GENERAL

OUTLINE OF CHANGES

- Due to the changes on the circuit diagrams, the troubleshooting procedures have been changed.
- Due to the changes on the SRS-ECU, the troubleshooting procedures have been changed.
- Due to the addition of an auto-cruise control system, the service procedure has been changed. <Vehicles with auto-cruise control>
- Due to the addition of a steering shift switch, the service procedure has been changed. <VR-X>

Illustration A

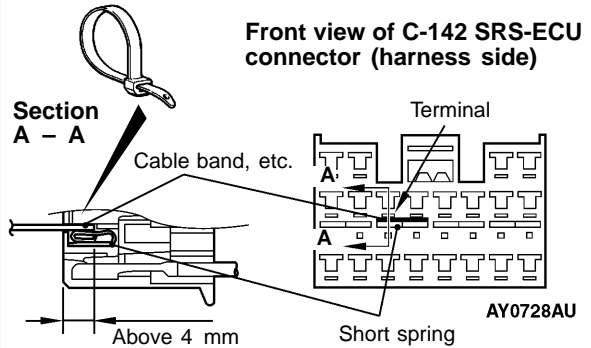
In order to release the short spring of SRS-ECU connector in the operation shown below, disconnect this connector to keep the squib circuit short-circuited.

- Insert a cable band, etc. (width: 3 mm, thickness: 0.5 mm), between SRS-ECU connector C-142 terminals 29 and 30 and the short spring, and release the short spring. (See illustration A.)

To avoid the occasion of inability of releasing the short spring due to insufficient insertion, insert the insulator for 4 mm or more.

◀F▶ CLOCK SPRING SUB HARNESS REMOVAL

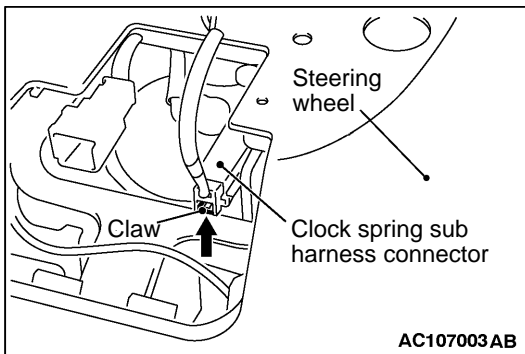
Pressing the claw of the clock spring sub harness connector towards the arrowed direction, disconnect the connector.
